11.1 - 20240682 - Development Application for Development Permit for Material Change of Use for Thirty-Two Rooming Accommodation Units and Short-term Accommodation (extension to Colonial Palms Motor Inn) - 2 Hermitage Drive Airlie Beach

PLANNING ASSESSMENT REPORT

11.2 - 20241307 - Development Application for Development Permit for Material Change of Use - Childcare Centre - 25-27 Parker Road, Cannonvale - 10SP332202 - Parker Road Investments Pty Ltd

Figure 1: Red arrows denote view direction of room windows

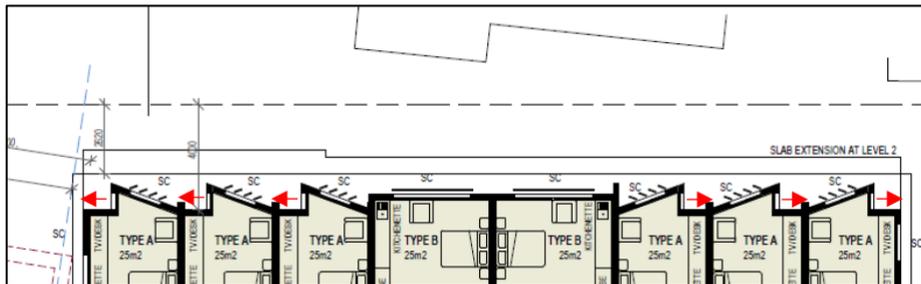
Levels 2 and 3 provide a 3m setback to windows and 4m to the building wall. While the window encroachment falls short of the AO requirement, it is a deliberate design choice to enhance privacy and reduce potential for onlooking by orienting windows toward Hermitage Drive and Shute Harbour Road. Each window on this boundary is also provided with an additional privacy screen to further reduce onlooking. The applicant has provided the following drawing to illustrate this outcome:

Figure 2: Separation distance to units at 10 Hermitage Drive

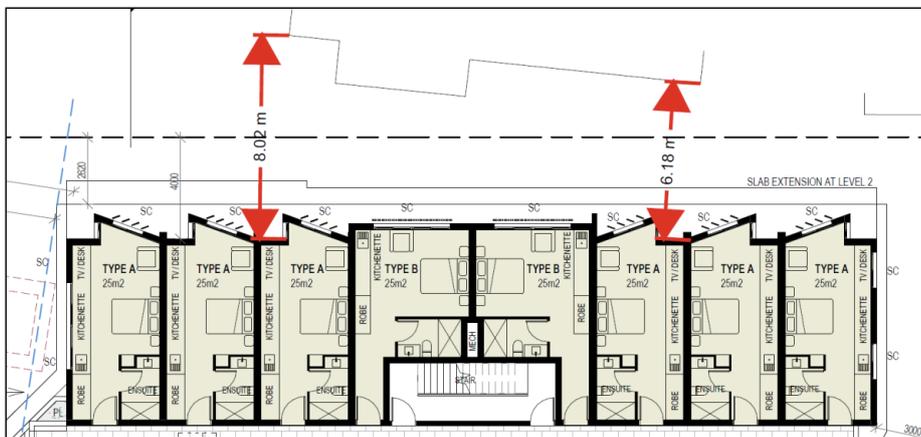
In addition to improving privacy and reducing onlooking, the varying window design adds visual interest through building articulation and screening. The result is a building separation of 6.18m to 8.02m to 10 Hermitage Drive, allowing adequate light and ventilation between structures. Landscaping at ground level reinforces this outcome and establishes that the northwestern boundary satisfies PO7. The applicant has provided a surveyed measurement between 10 Hermitage Drive and the proposed development:
